Supplementary Report
Planning and Development Board
9 June 2025

(6/d) Application No: PAP/2022/0423

Land to the south of Watling Street, Caldecote, CV10 0TS

Updated Review of A5 Mitigation

JOB TITLE Mira / Extra Room Self Storage			CLIENT Mark Simpson	
DRAWING TITLE A5 – Drayton Lane – Woodford Lane Junctions Concept Mitigation Package 1				
SCALE 1:1000@A3	DRAWN BY BP	DATE 07/05/25	DRAWING No 24316-04-GA	REVISION

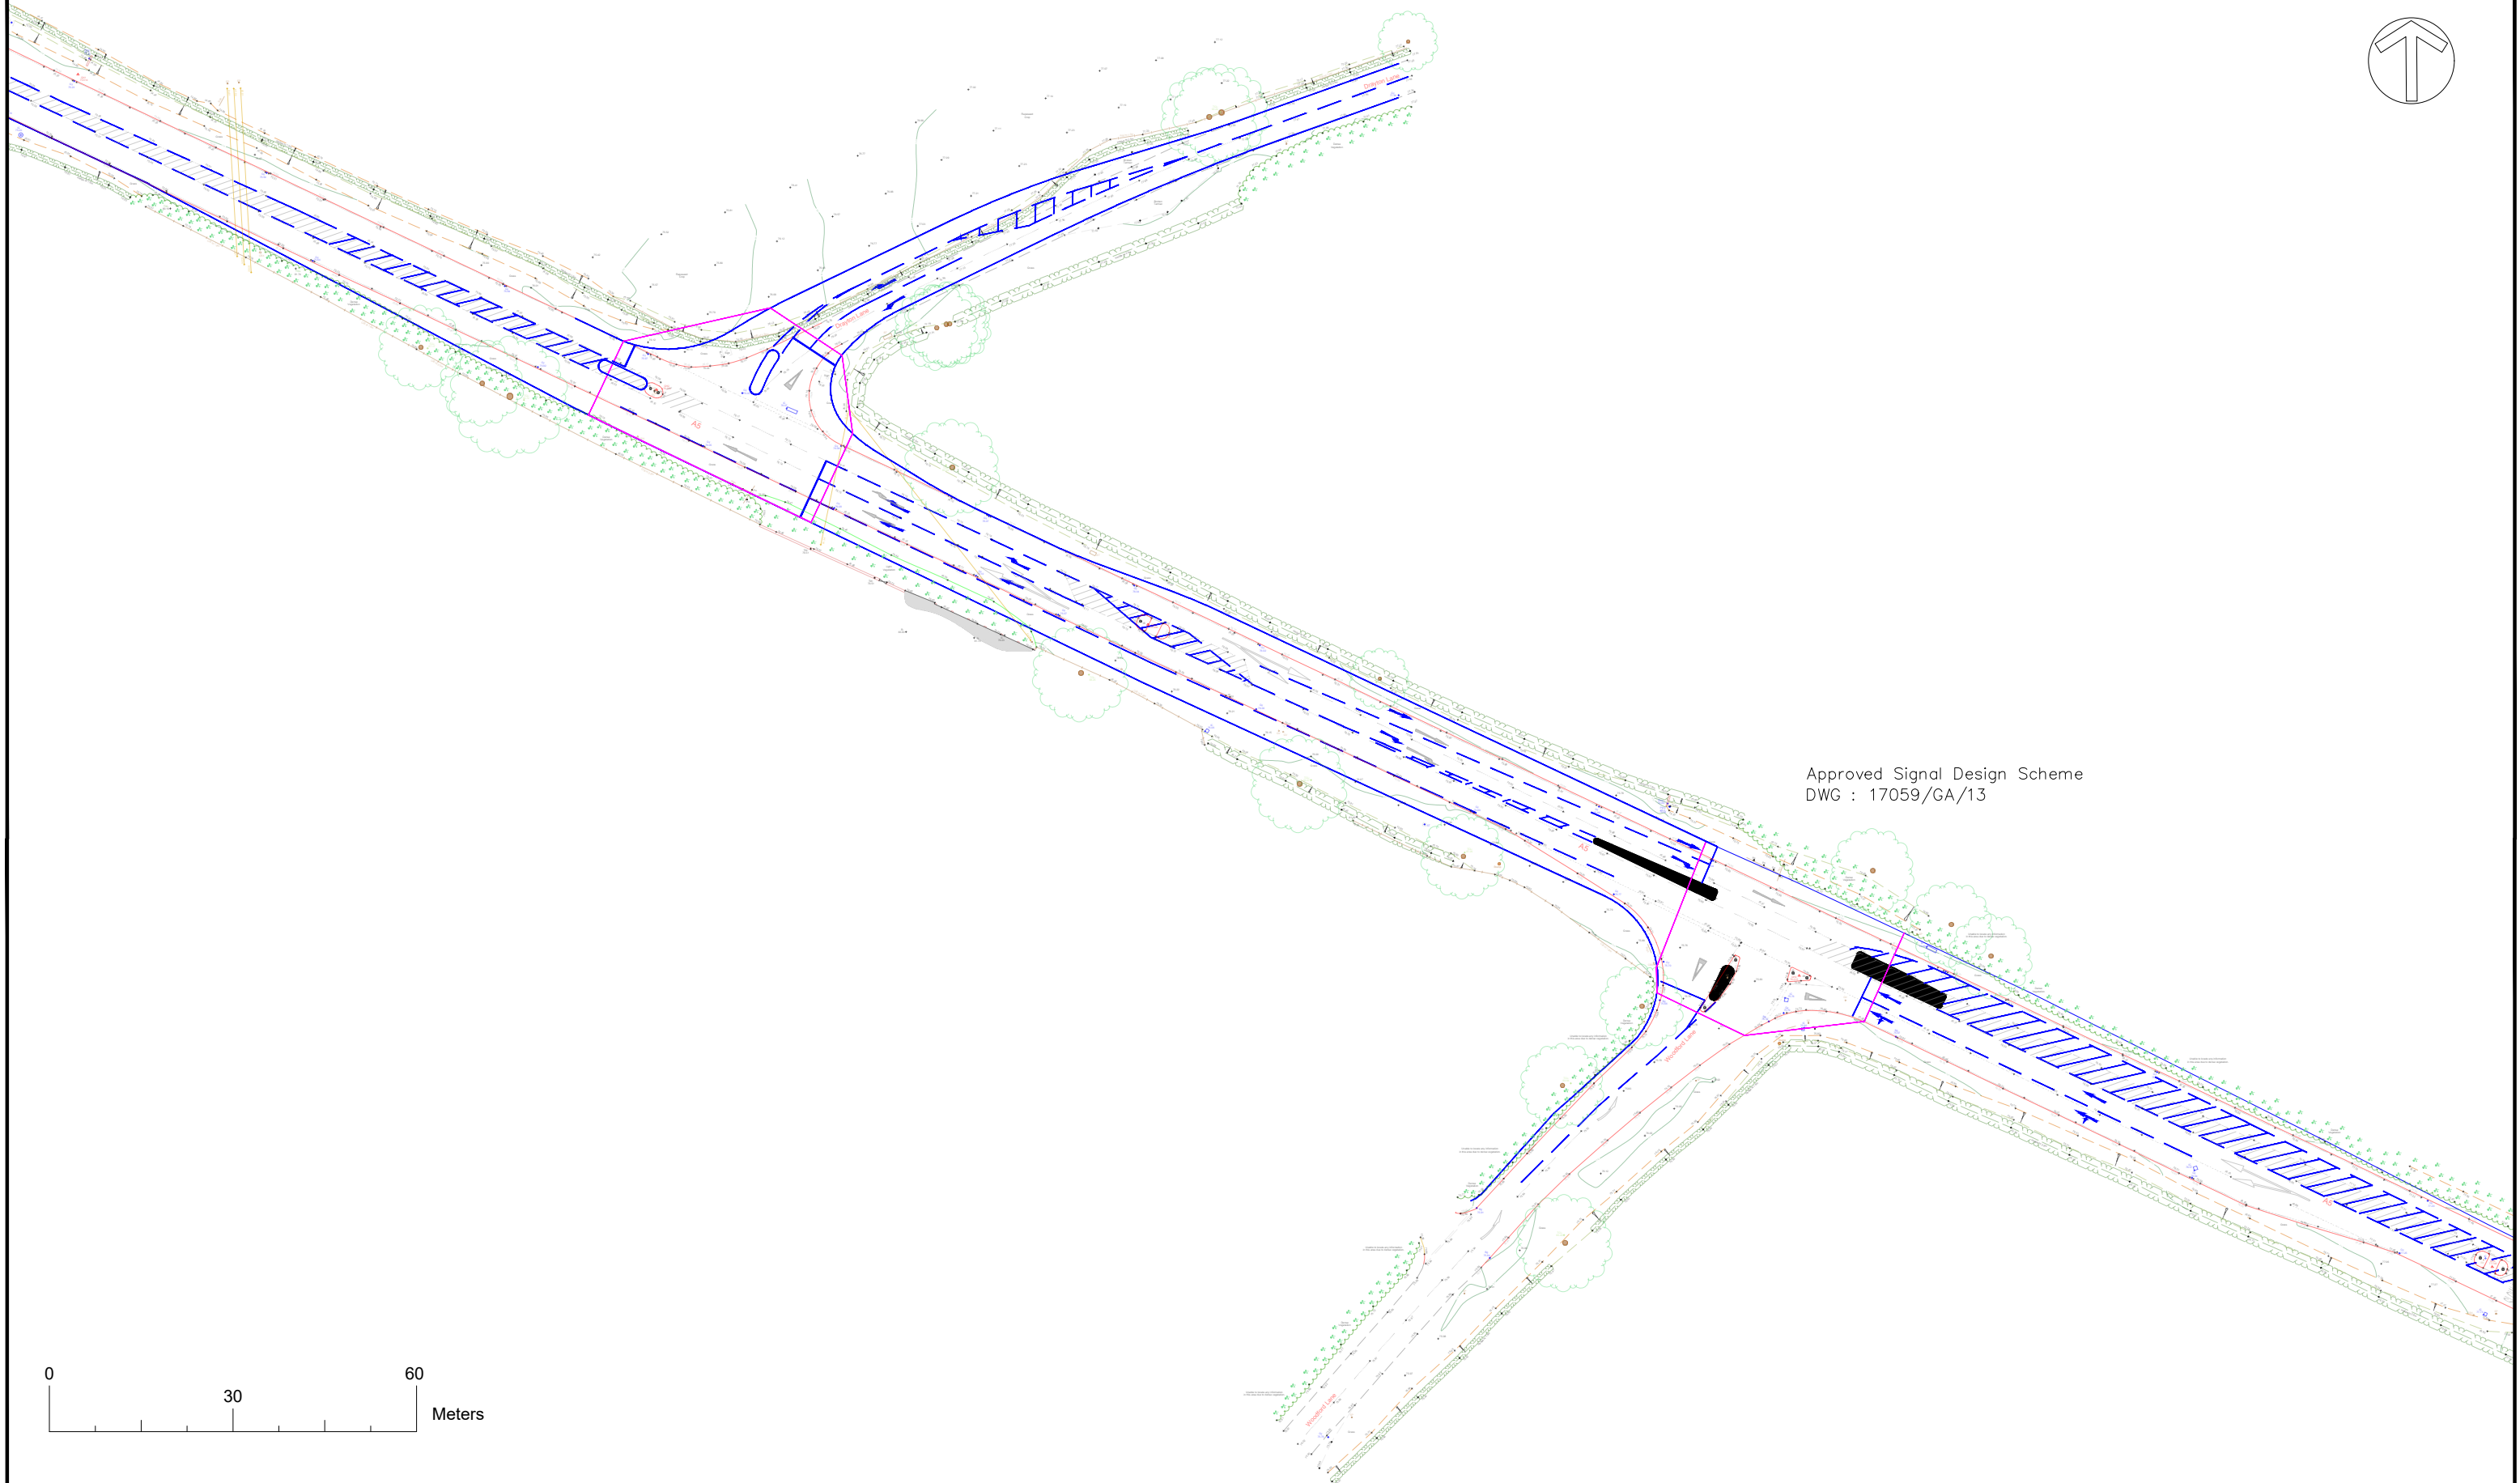
1. No cruise speeds between arms identified.
2. Arm 8 - Drayton Lane:
 - a. In line with the proposed drawing prepared by DTA the short-lane should be provided for left-turning traffic not right.
3. Arm 12 - A5 East:
 - a. 50:50 split for ahead traffic is unlikely due to the presence of a give-way right-turn into Drayton Lane. Drivers will likely be aware of this and the potential for queuing and therefore will likely select to drive in the nearside lane.
 - b. Within the LinSig Arm 12/2 (right-turners) are giving way to Arm 12/1 this is wrong and should be giving way to Arm 7 (A5 West).
 - c. Neither lane 1 or 2 have been inputted as nearside lanes, therefore overestimating the saturation flow.

1. It is unclear why the degree of saturation and queuing on the A5 eastbound is highest in the AM1 scenario, despite the traffic flows increasing in the subsequent scenarios.
2. No swept-path analysis shown for HGVs accessing / egressing Drayton Lane.
3. No signal intervisibility shown.
4. No highway boundary shown.

- 4.1 To address GA comments the general arrangement drawing has been updated as shown at **Appendix B**. It is now based on a topographical survey commissioned by the client (provided separately at **Appendix D**).

- 4.3 The highway boundary extents are shown. In practice our client is willing to contribute land in the northwest quadrant of the Drayton Lane junction to support an appropriate layout and hence land is not considered to be a constraint.

- 4.4 Signal intervisibility envelopes are shown. Intervisibility is achievable at the Drayton Lane junction. Forward visibility to a primary signal head is achievable on all approaches. A nearside primary signal head can be provided on the Drayton Lane minor arm.

JOB TITLE		CLIENT		
Mira / Extra Room Self Storage		Mark Simpson		
DRAWING TITLE				
A5 – Drayton Lane – Woodford Lane Junctions Concept Mitigation Package 2				
SCALE	DRAWN BY	DATE	DRAWING No	REVISION
1:1000@A3	BP	07/05/25	24316-03-GA

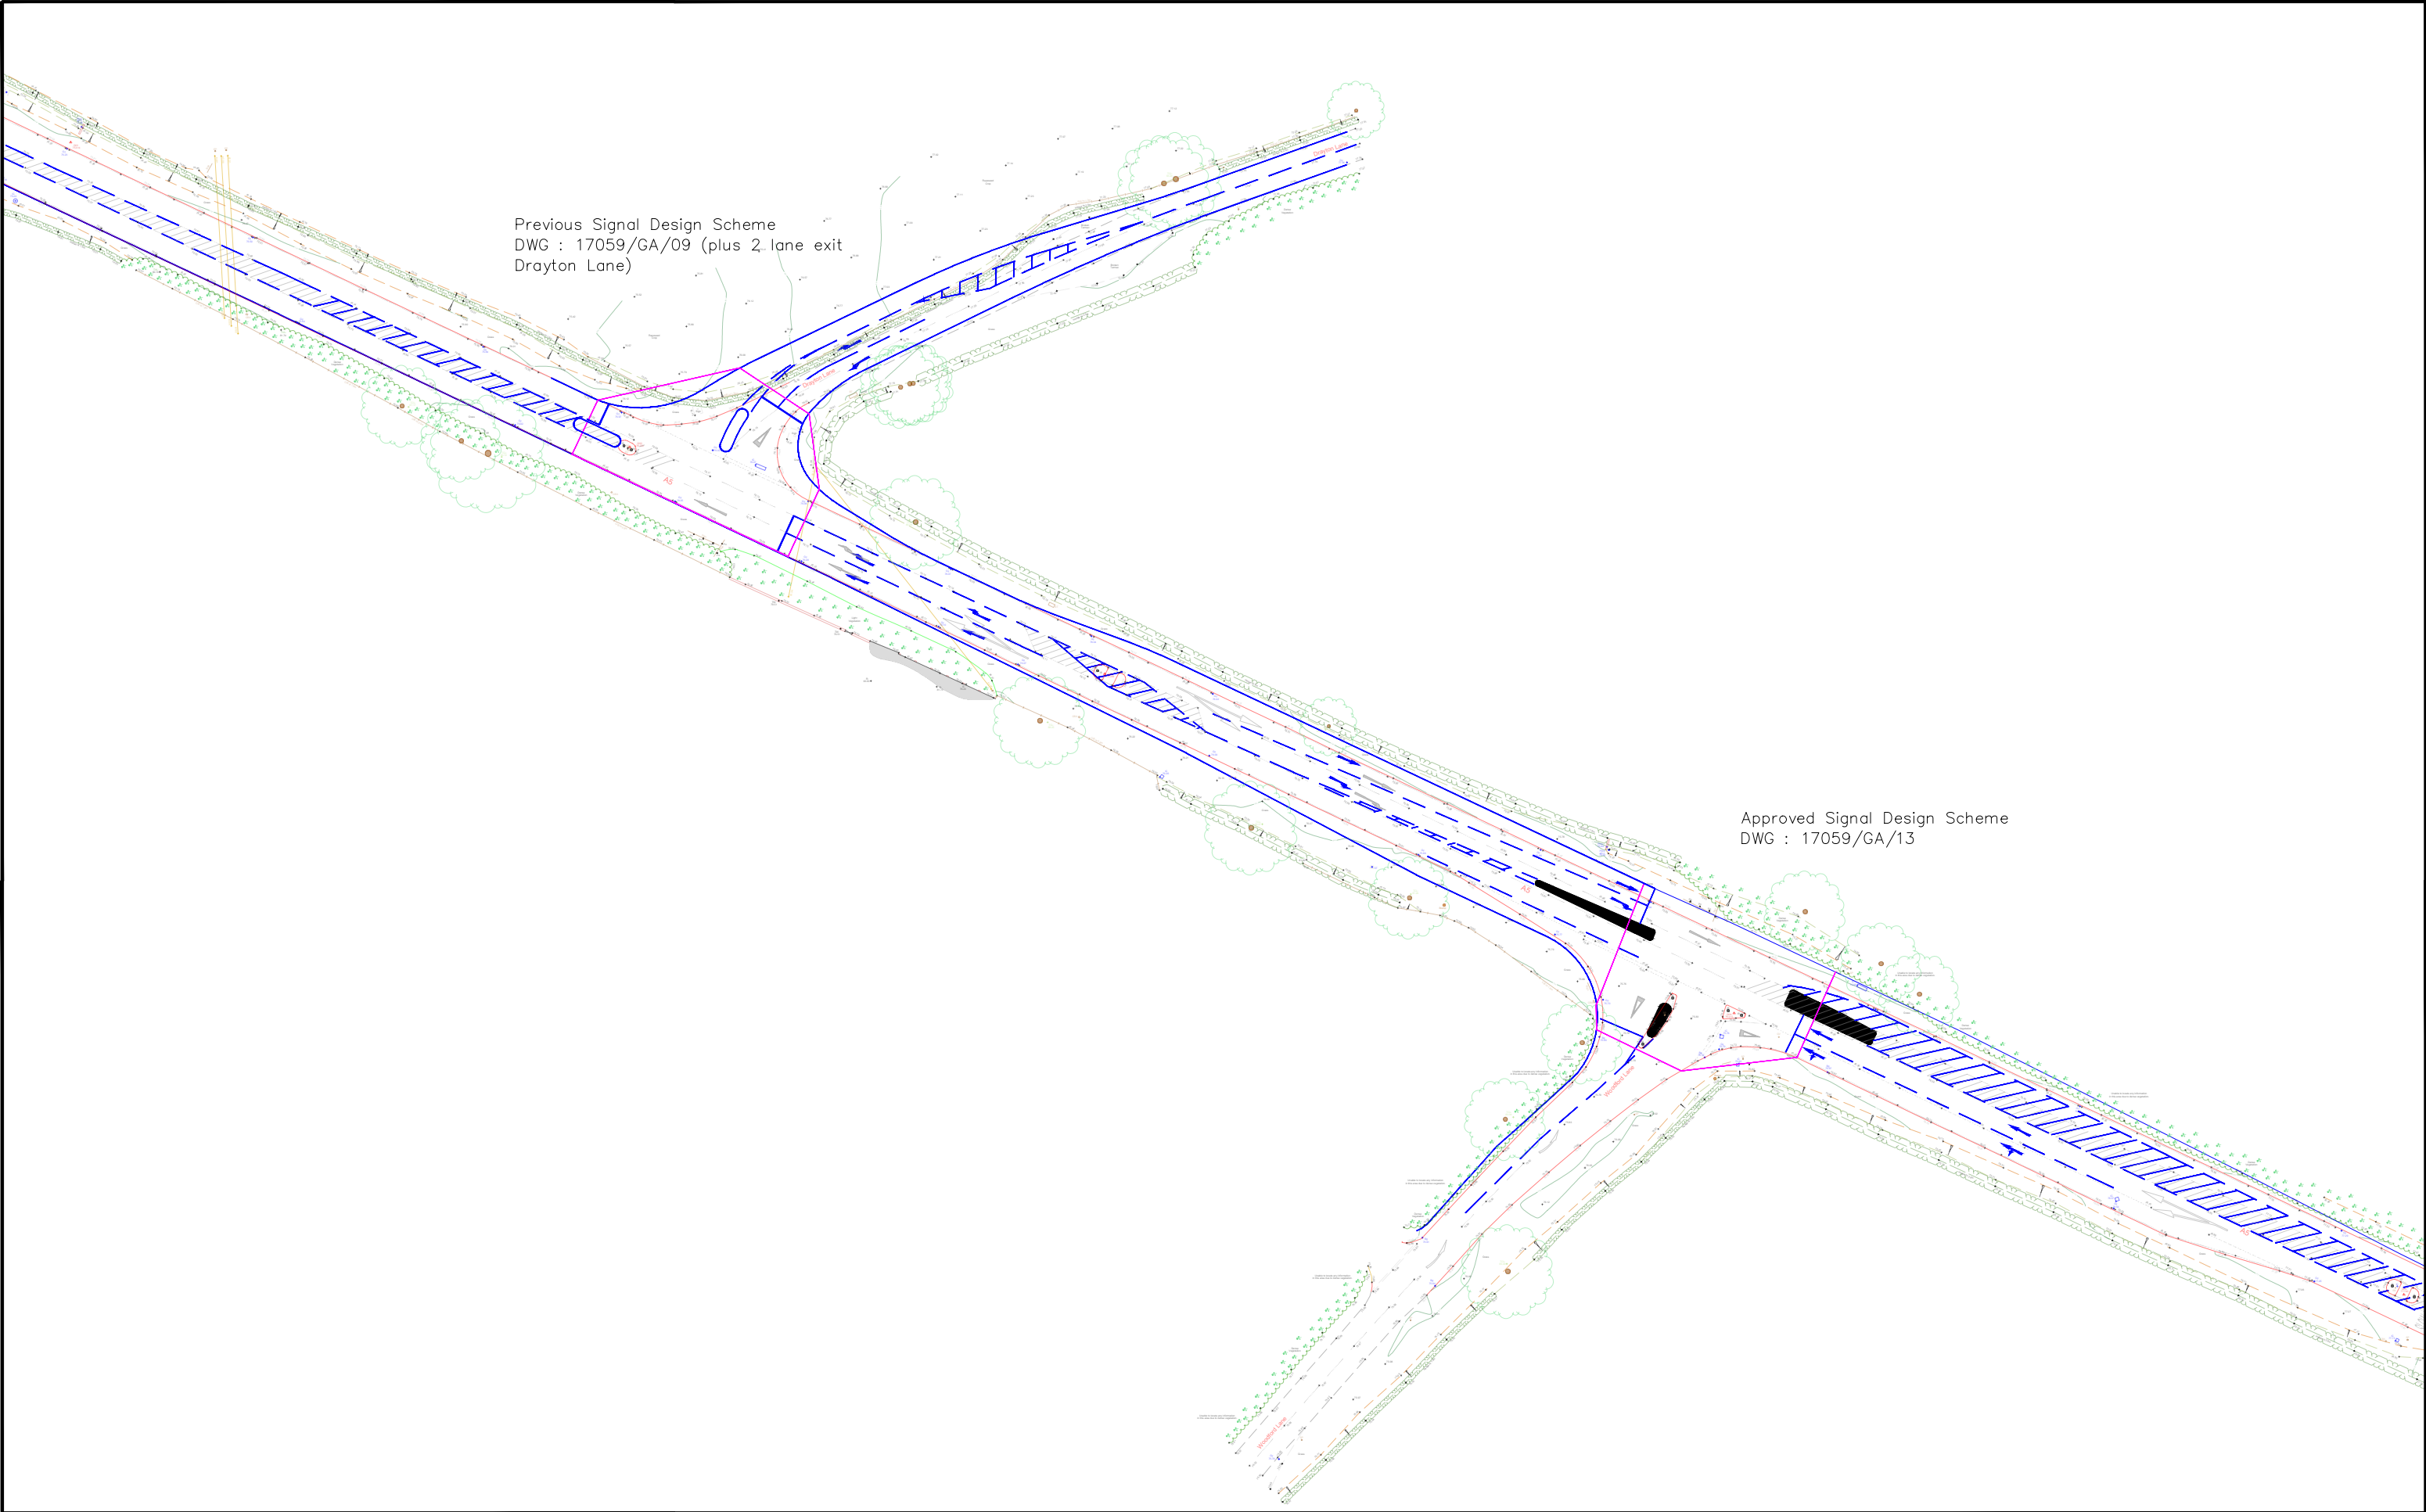
- 2.4 The issue for the Drayton Lane junction is that there could be confusion about whether downstream delay is attributable to the junction or funnel. The design solutions here are either to extend two westbound lanes through both junctions and locate the funnel to the west of both junctions OR link the timings of the junctions so they are co-ordinated such that ahead traffic from Woodford Lane junction is not held at the Drayton Lane junction when the flare is operational. The DTA concept scheme adopted the former approach but either approach is workable here. Both options are shown on the drawings at **Appendix B**.
